**TOWN OF SUMMERVILLE
DESIGN REVIEW BOARD – AGENDA
Summerville Municipal Complex
Summerville Council Chambers or Zoom Virtual Meeting
September 17, 2020 4:00 p.m.**

Design Review Board Minutes
Thursday, August 20, 2020
Zoom Virtual Meeting

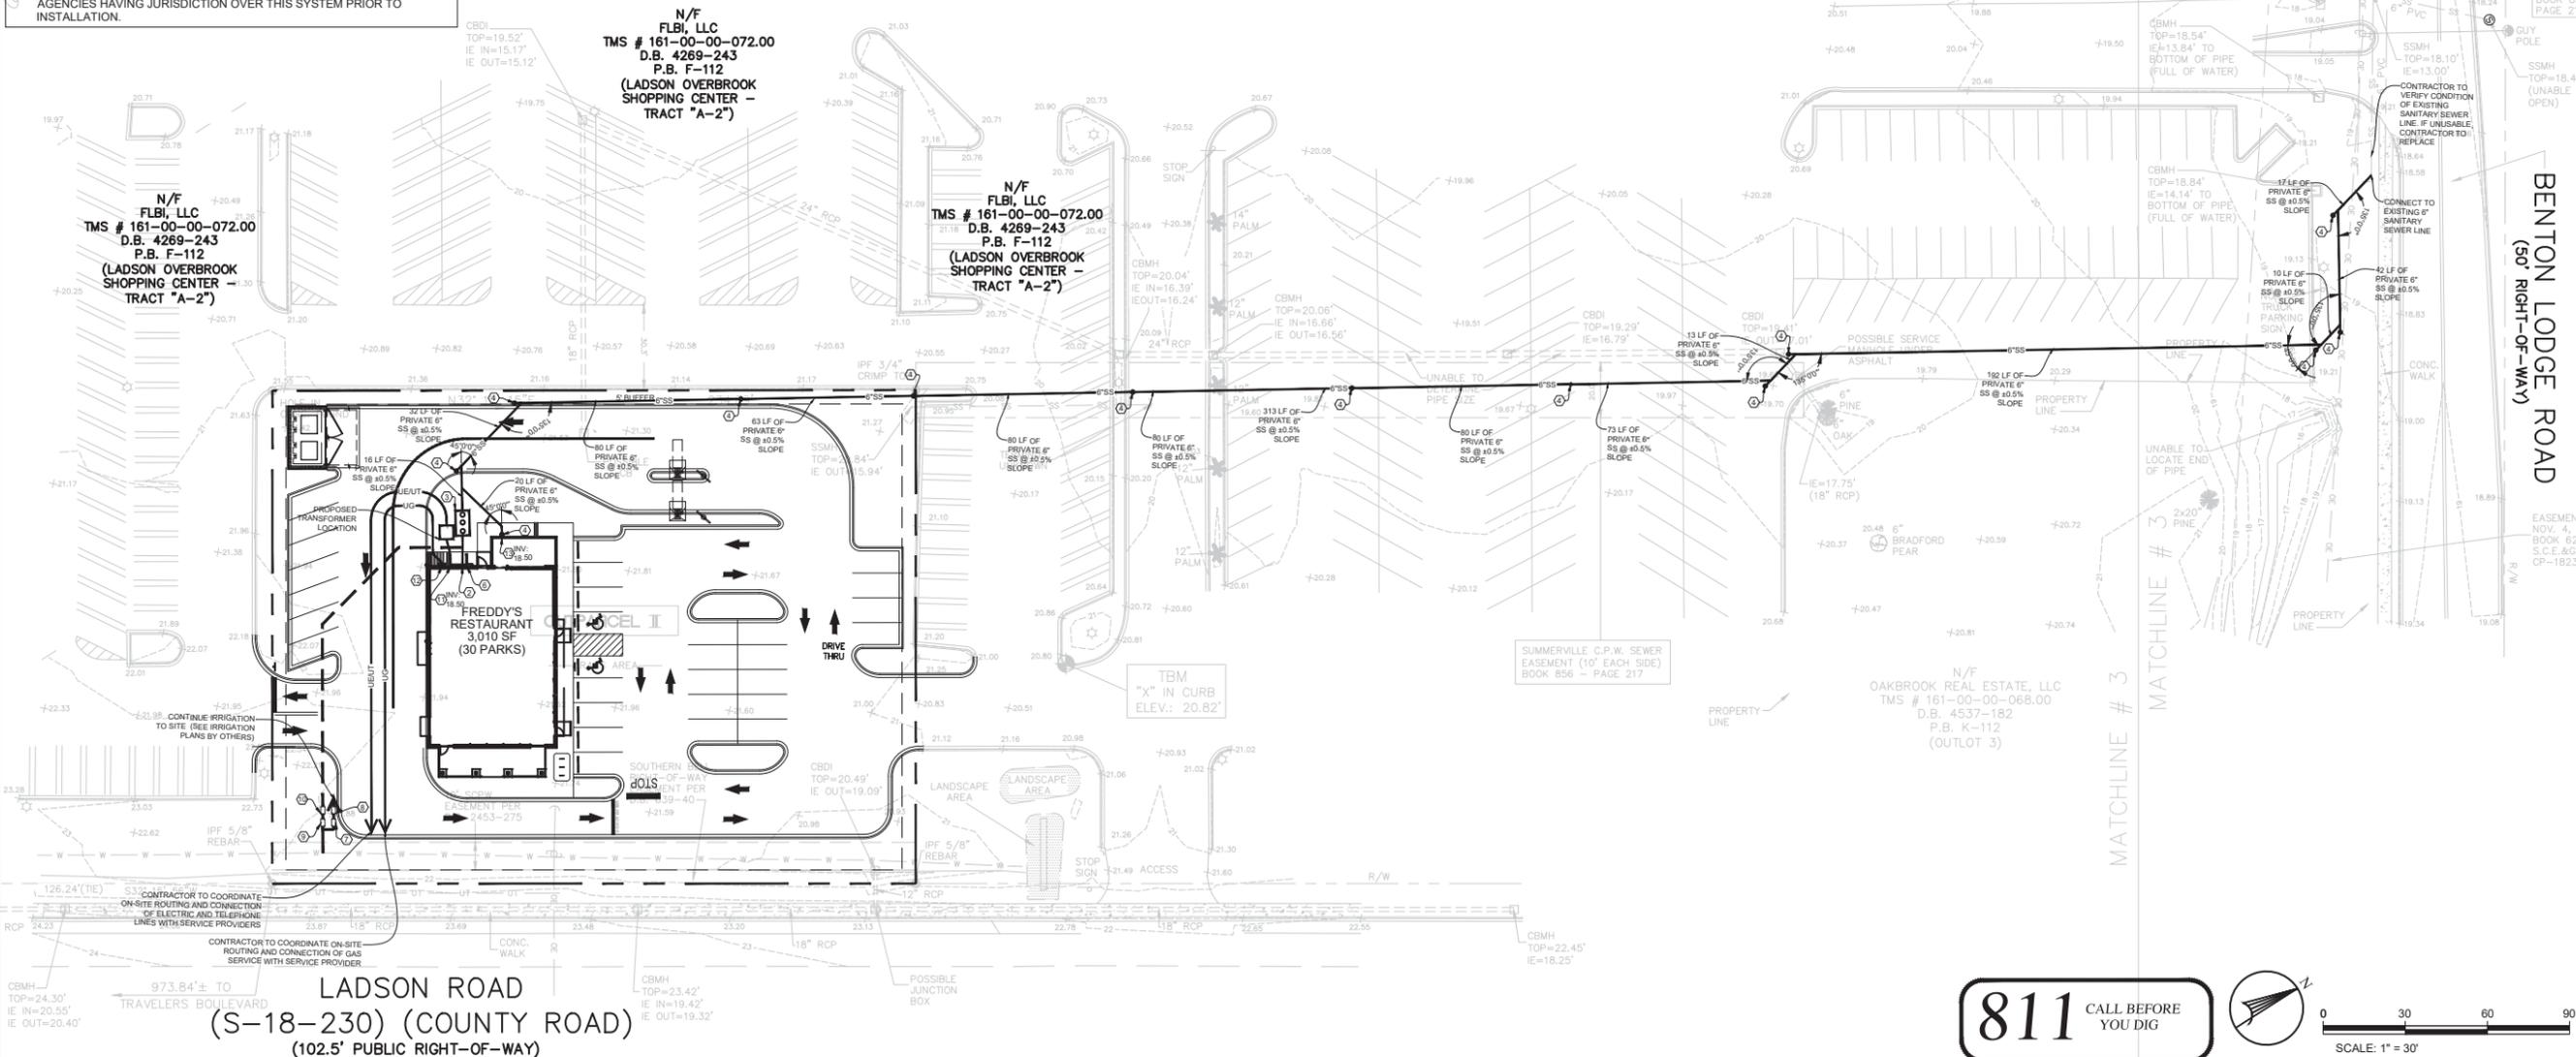
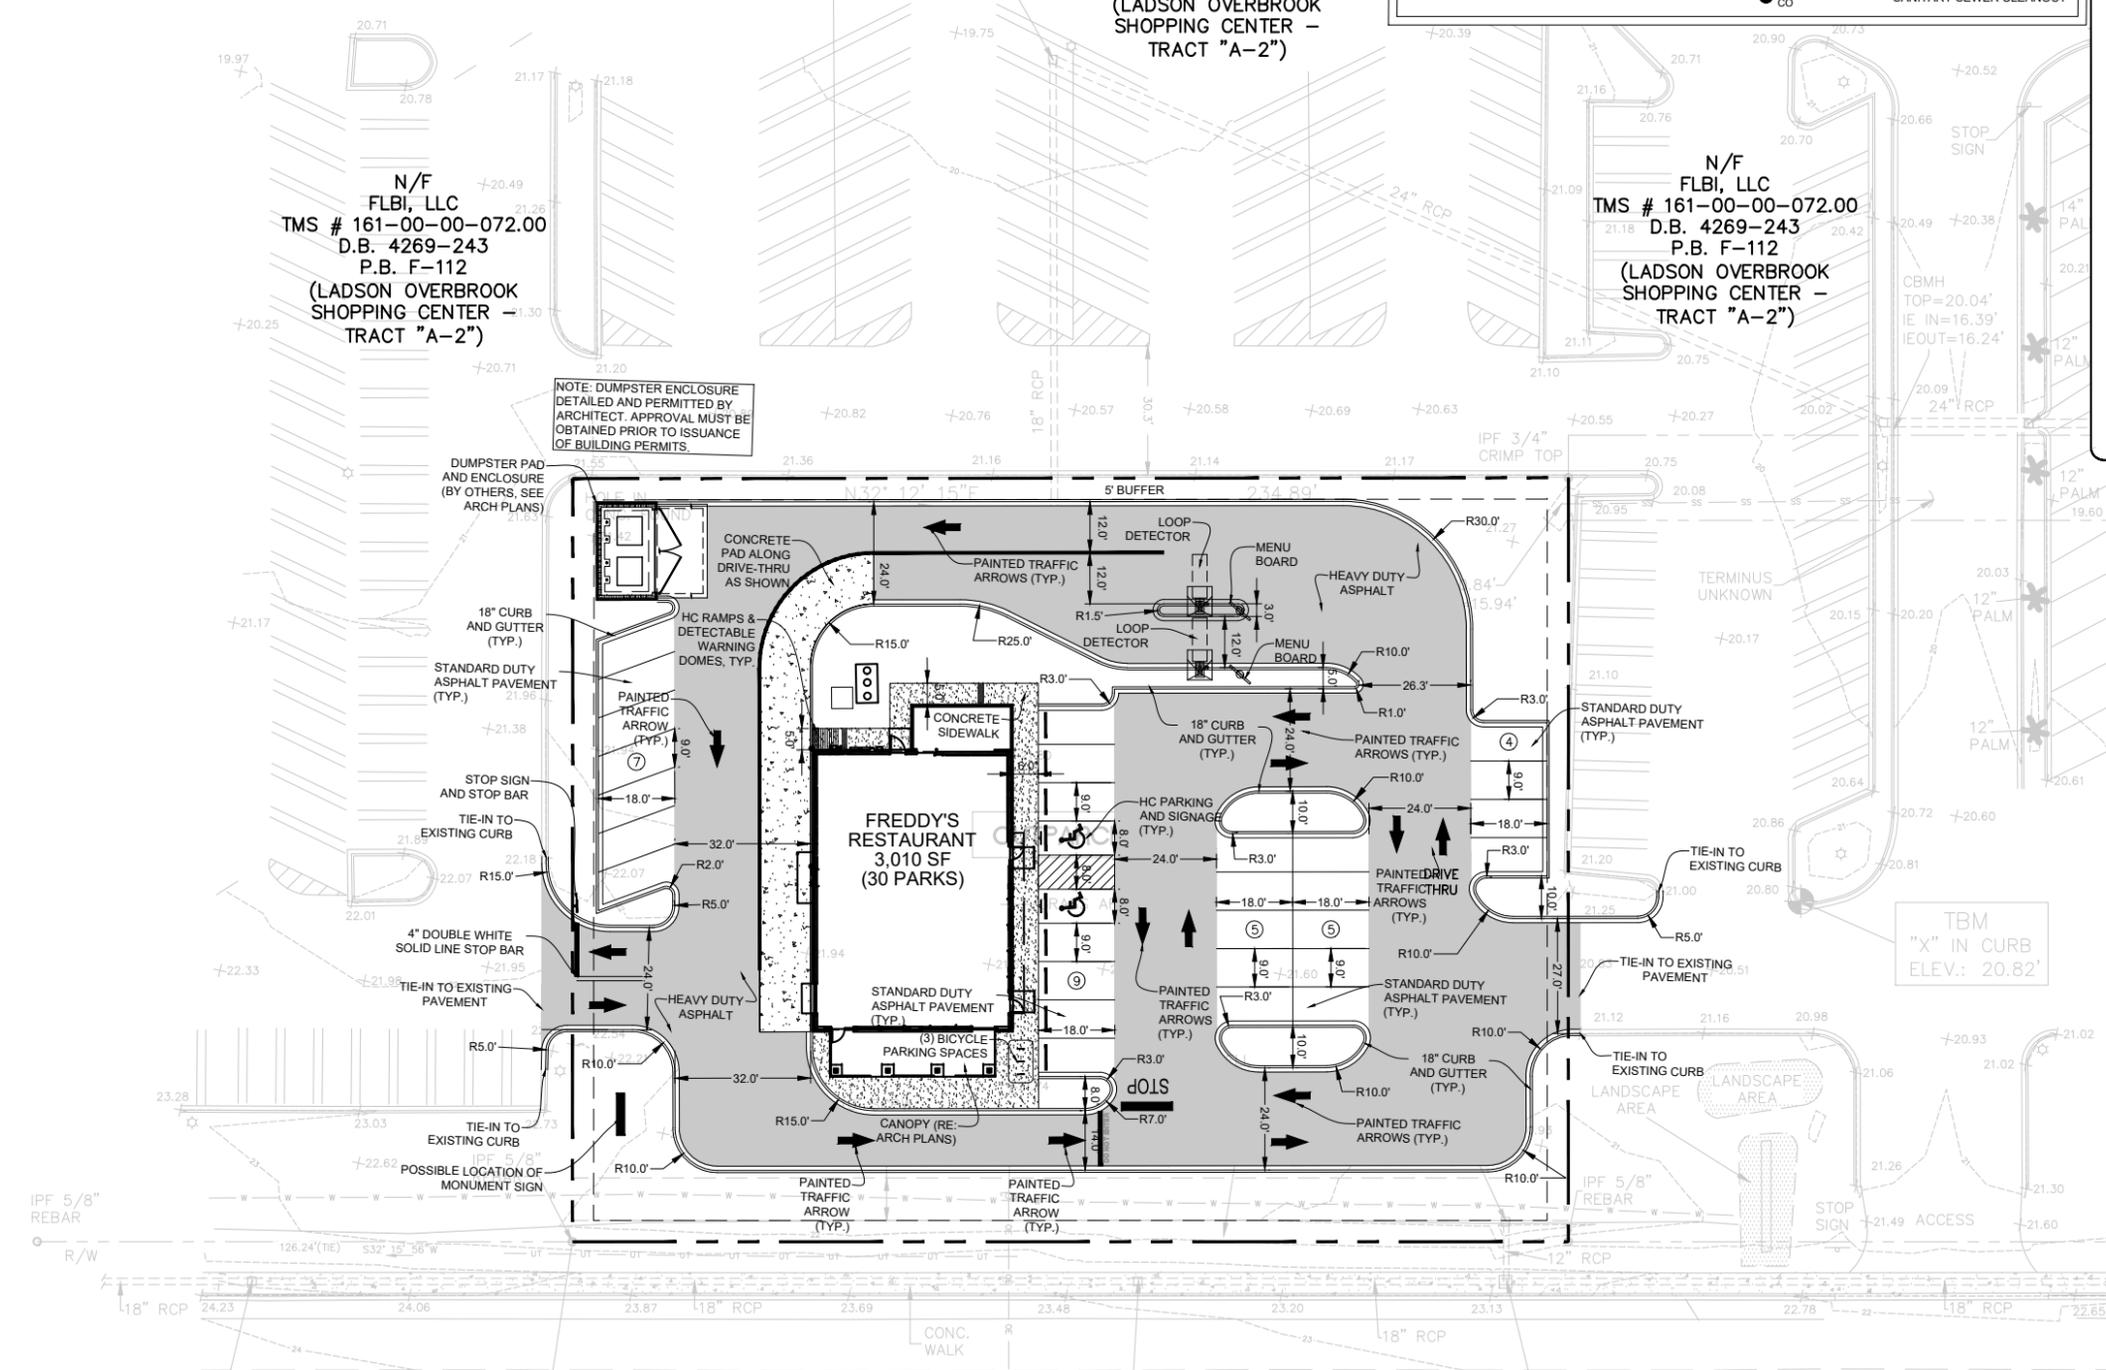
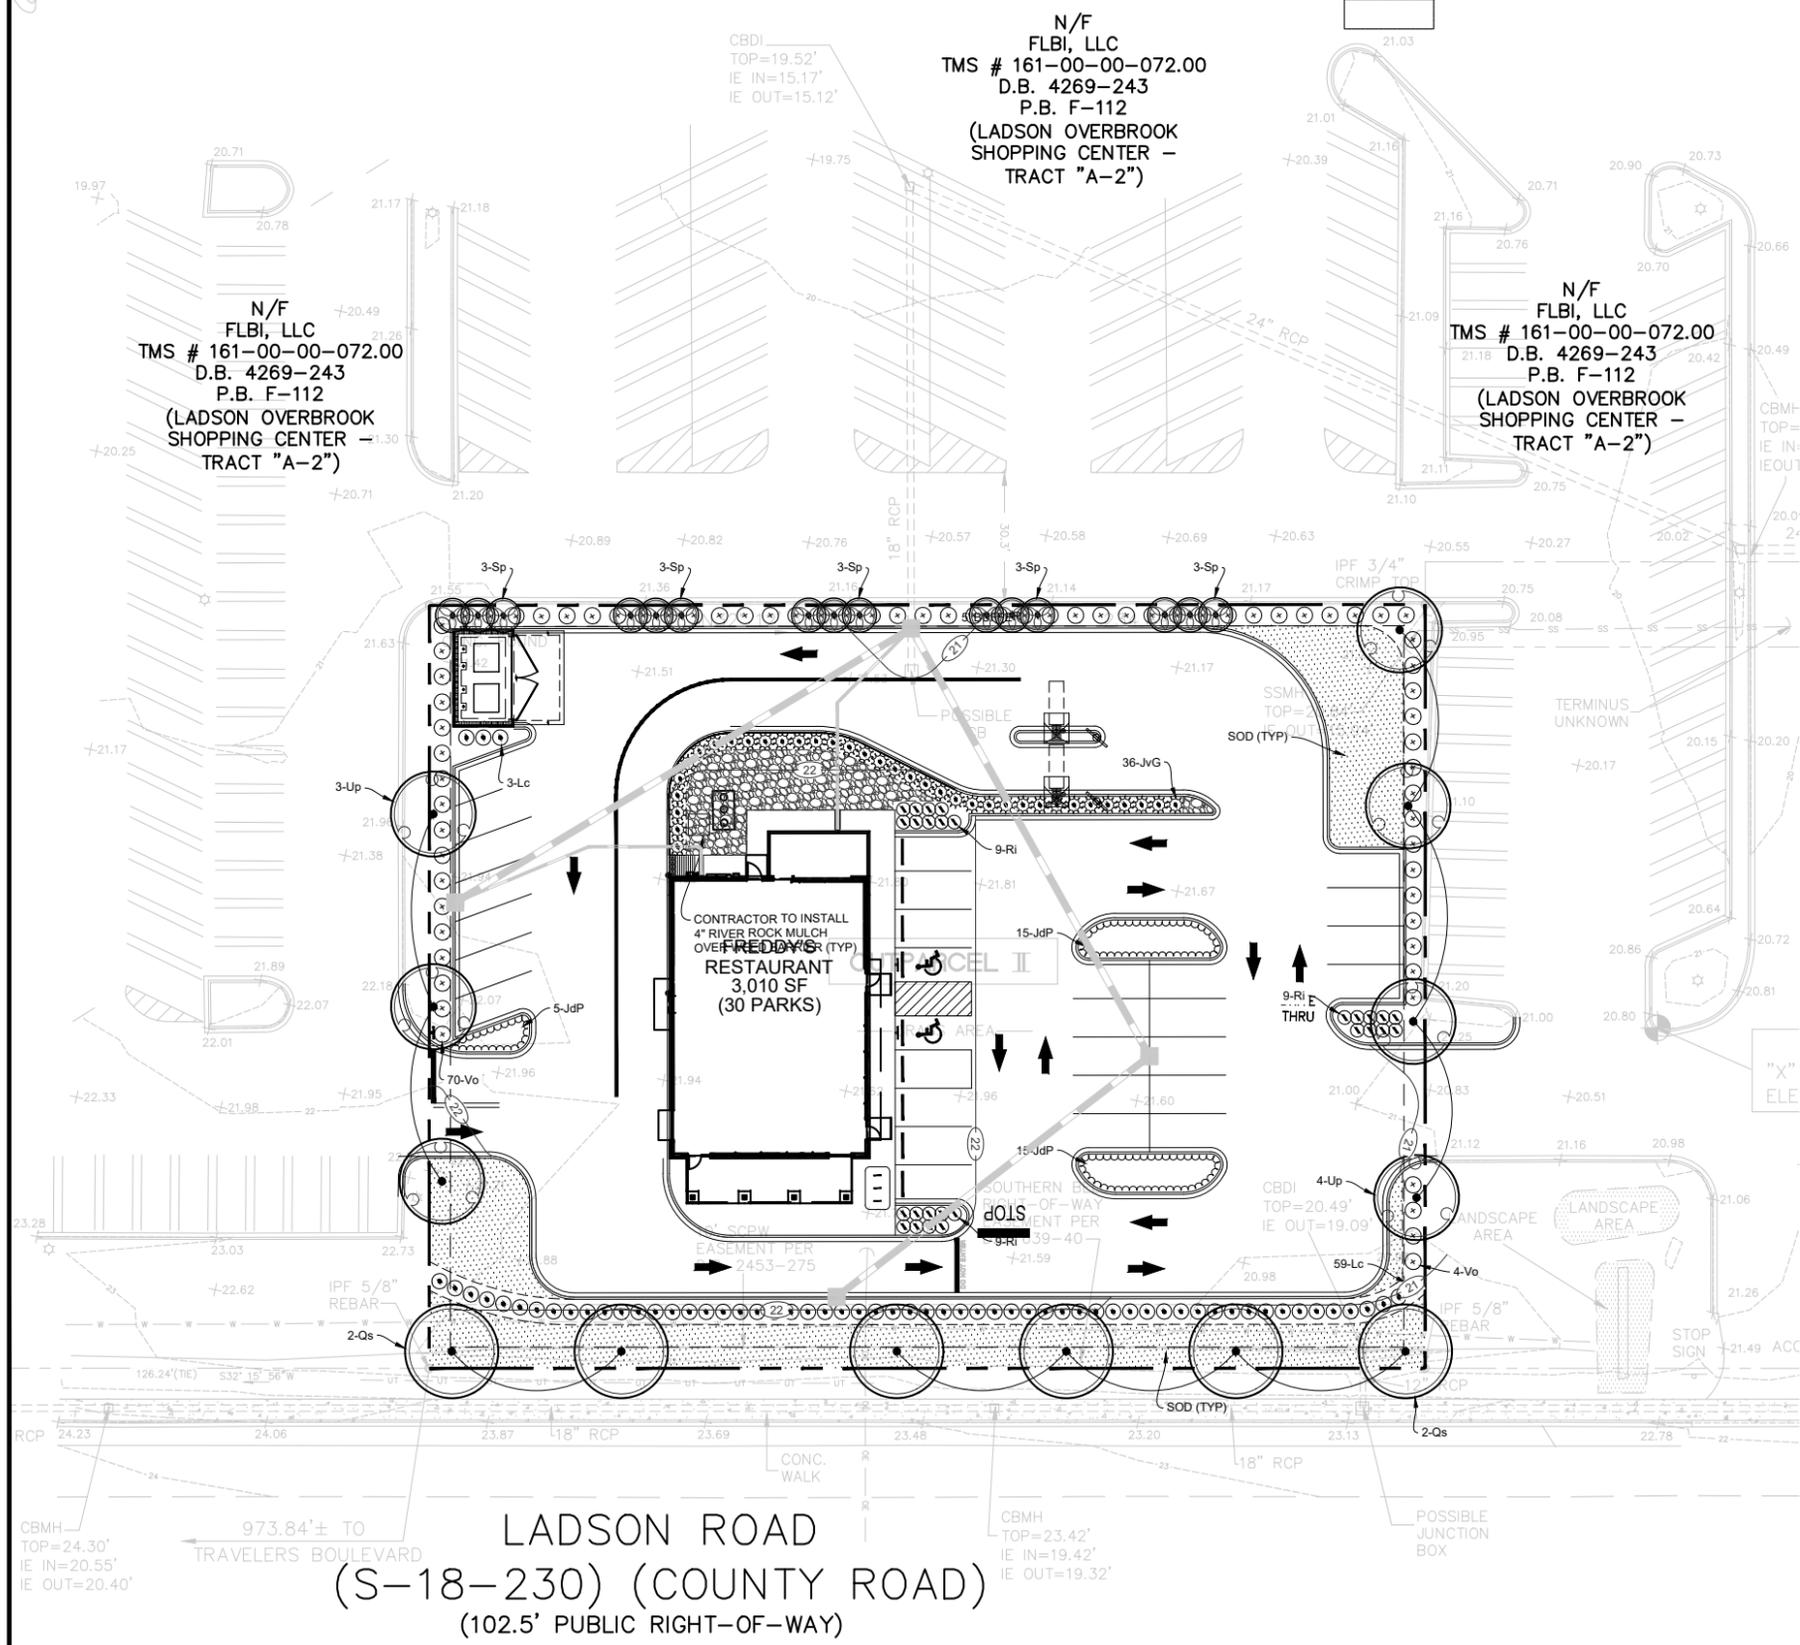
Based upon staff review the following comments must be addressed to meet requirements. A sidewalk connection to the existing sidewalk along Ladson Road. The required parking exceeds the maximum, they are providing the required pervious surface for the excess parking, but the pervious pavement has not been shown on the site plan. A dumpster detail is required, and should be constructed of materials to match the building. No trees are shown in the landscaped islands, this does not meet the requirements of Section 8.5.3. Cabbage Palmetto are not considered canopy trees, and cannot be utilized to meet the minimum planting requirements for canopy trees. A phot metric plan and signage plan have not been submitted.
